**PLANNING COMMISSION  
STAFF REPORT**

**SUBJECT:** Planning and Zoning Permit Nos. 09-300-04 (Tentative Subdivision Map), 09-500-02 (Special Use Permit), and 09-535-01 (Density Bonus).

- 2) **Project Description and Applicant:** A request for approval of: a special use permit to construct a three-story 31,346 square-foot multi-family dwelling with 16 condominiums on a vacant 34,636 square-foot lot; a 35% density bonus for four affordable units and 12 market-rate units; and a tentative subdivision map to subdivide for 16 residential condominium units. The applicant also requests concessions pursuant to State density bonus law for the development standards applicable to front setbacks, side setback, interior yard space, open area, and guest parking. The project site is located at 5101 Saviers Road, at the southwest corner of Saviers Road and Pleasant Valley Road (APN's 222-0-102-015, 200). Filed by Lauterbach & Associates Architects, on behalf of owner Lorenzo Castillo, 300 Montgomery Ave., Oxnard, CA 93036.

PRELIMINARY LANDSCAPE PLAN - L1

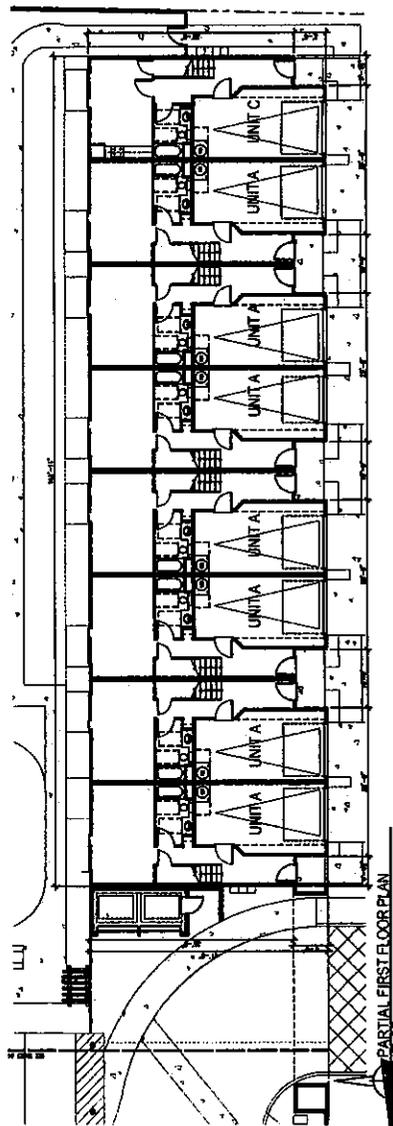
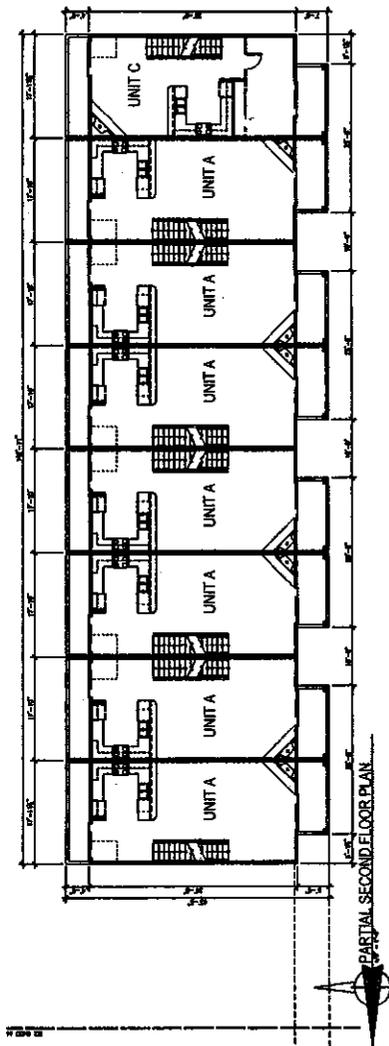
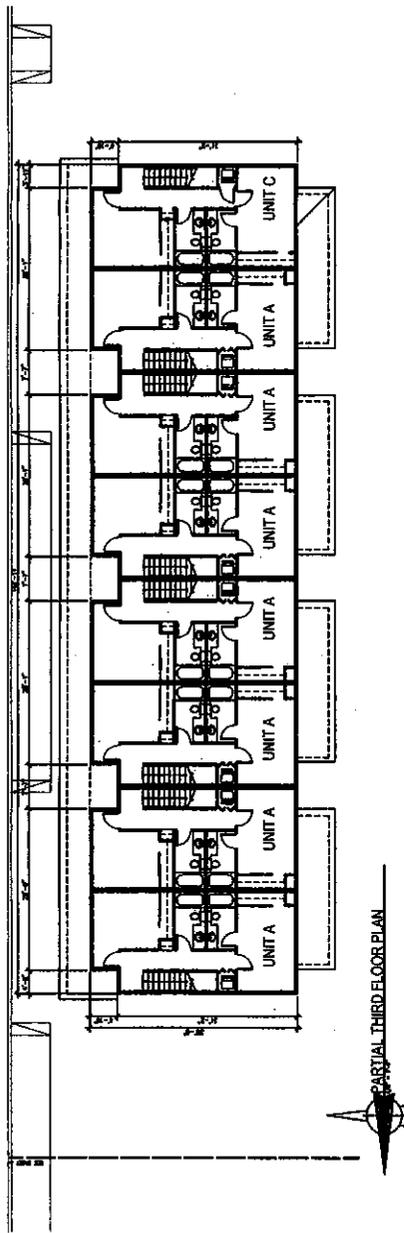
- 15) Revise landscape plan to show concrete driveway aprons 20 ft. wide to match driveway width (slopes of aprons cannot have groundcover or other landscaping – must be concrete to match).

EXTERIOR ELEVATIONS - A5

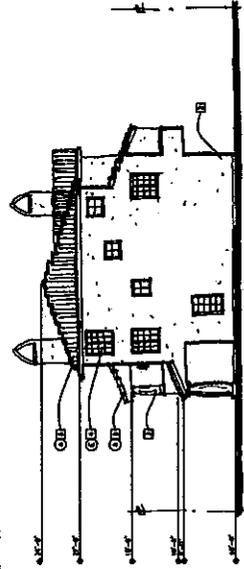
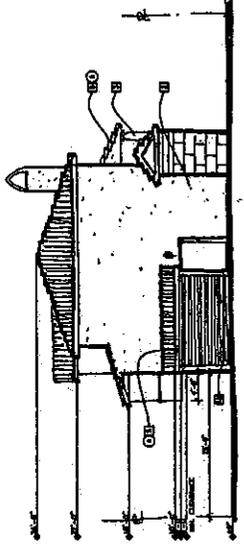
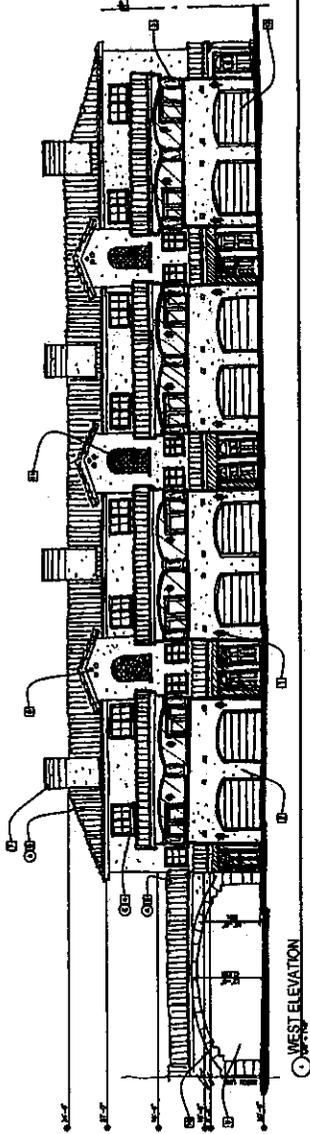
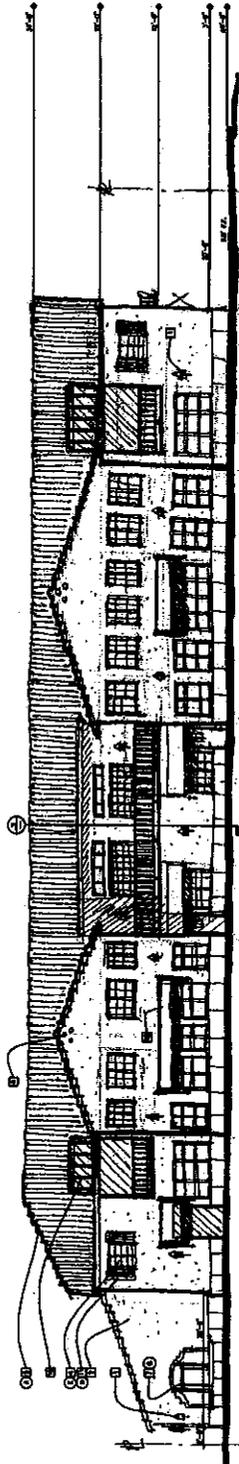
- 67) Cantilevered stucco covered balcony at East Elevation (Units A&C) is long, monolithic and visually "heavy". Suggest providing first floor wing walls between units to "support" balcony above and provide outdoor privacy at stoops. (Sheet A-5).

- 68) Second floor and Third floor portion of wall at north elevation on Sheet A-5 is blank. Some type of architectural detailing (possibly windows) is recommended for this area, but there are potential problems with fire rating, building separation, trash enclosure location, privacy, etc.

- 69) The partial West elevation on Charles St., at the 3 story units 'A' & 'C', does not have the base detail as the rest of the west elevation and north (Pleasant Valley) elevation. Suggest wainscot detail at garages to keep a consistent appearance. (Sheet A-5)

EXTERIOR ELEVATIONS - A6

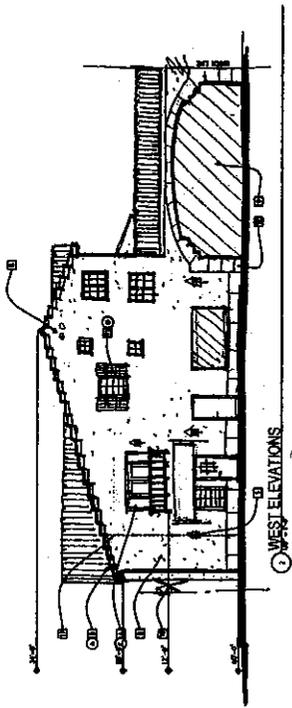
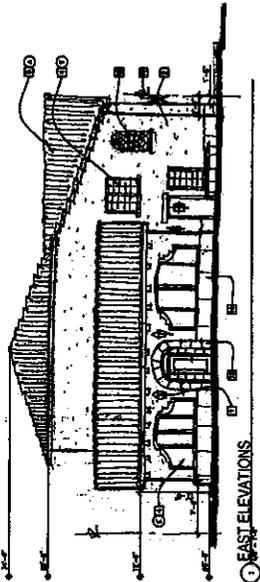
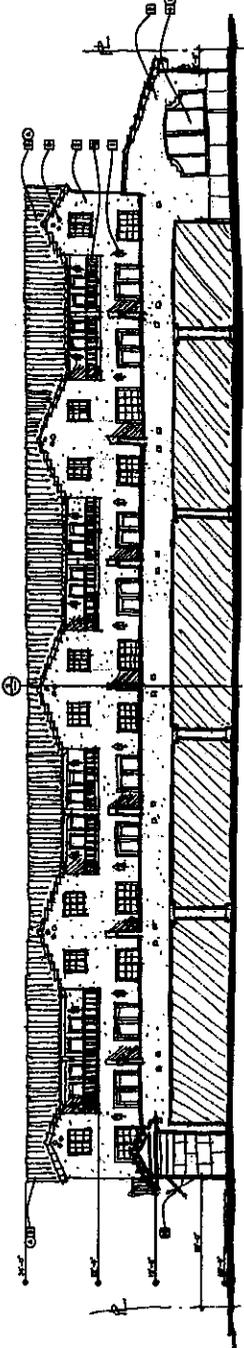
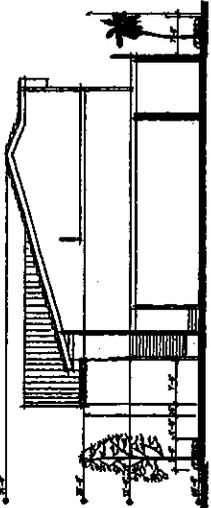
- 71) The partial west elevation at corner of Pleasant Valley and Charles St. (unit D) contains a 3 story flat wall next to garage opening. Recommend articulation, such as stepping second/third floor wall in or out to create another wall plane or awning over first floor garage opening. (Sheet A-6).
